**Independent Engineering Assessment
of the
New Orleans
Temporary Outflow Canal Pumps**

Prepared by

PARSONS

February 27, 2009

Figure 2-3—Flow Measurement Points

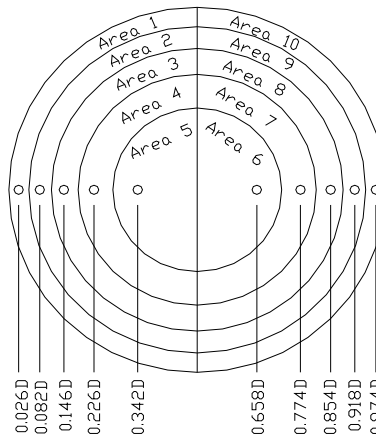
The ERDC report indicates numerous difficulties in getting consistent readings with the test setup to measure flow. Due diligence was exercised by the investigator to minimize the error related to velocity differences in the discharge piping at the point of flow measurement by taking extensive cross-sectional measurements and using accepted standards to correct the data (United States Bureau of Reclamation [USBR] Water Measurement Manual). The flow measurement points are shown in Figure 2-3. The collected data was corrected using standard procedures to account for the differences in test operating speed so comparisons could be made with the contract requirements and a previous test noted as "Measured MWI Analysis-288 rpm."

USBR 10-pt Velocity Traverse. D = pipe diameter. The dimensions are extracted from the “Data Report on Factory Tests of Discharge and Total Dynamic Head of MWI Pumps Used on New Orleans Outfall Canals.”

Figure 2-4—Head-Discharge Curves Design

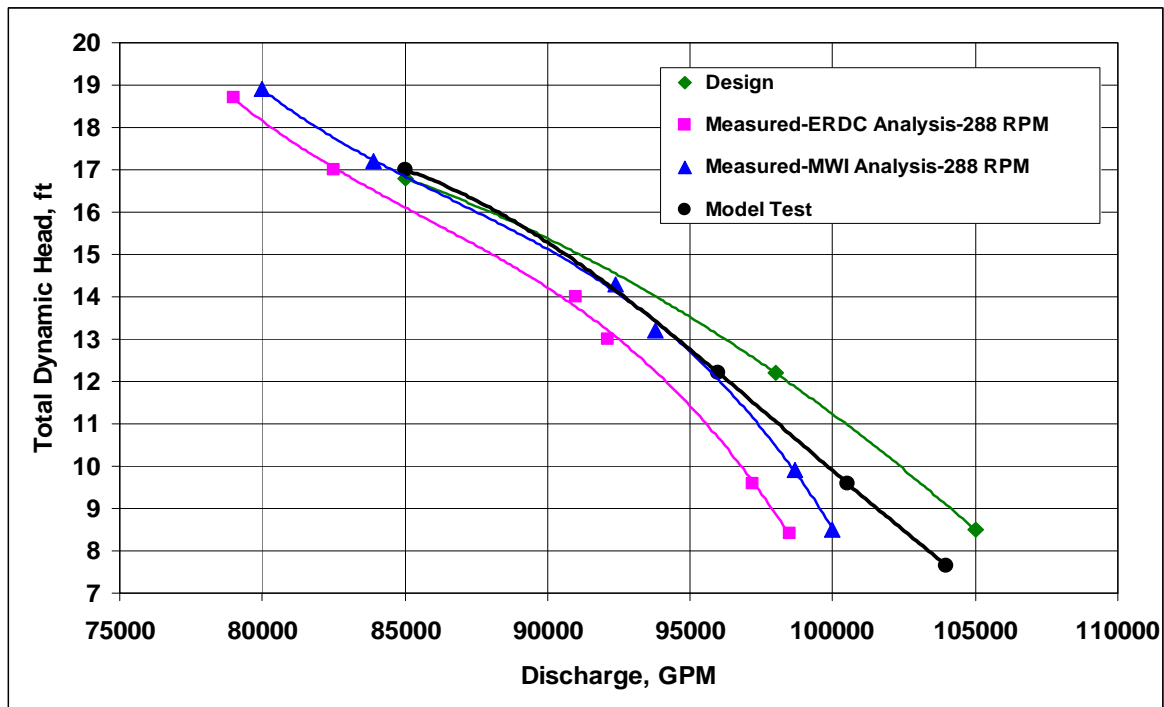
Figure 2-4 shows head-discharge curves design, measured with ERDC analysis and with MWI analysis, the discharge is based on the average of all 4 traverses.

The size of these pumps necessitated a very large quantity of water in order to run a full test. The water was pumped from a sump and was continuously recirculated through the test set up for the duration of the test. The sump size available at the manufacturer's facility made it difficult to achieve the desired conditions to obtain the flow data, since the smaller sump size resulted in turbulence, aeration, and elevated water temperatures for the recirculated water, all of which can adversely impact the results. Because of these types of abnormalities in testing pumps of this size, it is not uncommon within the industry to gather the performance data from a scaled model rather than from a full-sized pump. It is the opinion of the Parsons team that results from the factory prototype pump test are not reliable to accurately predict flow rates.
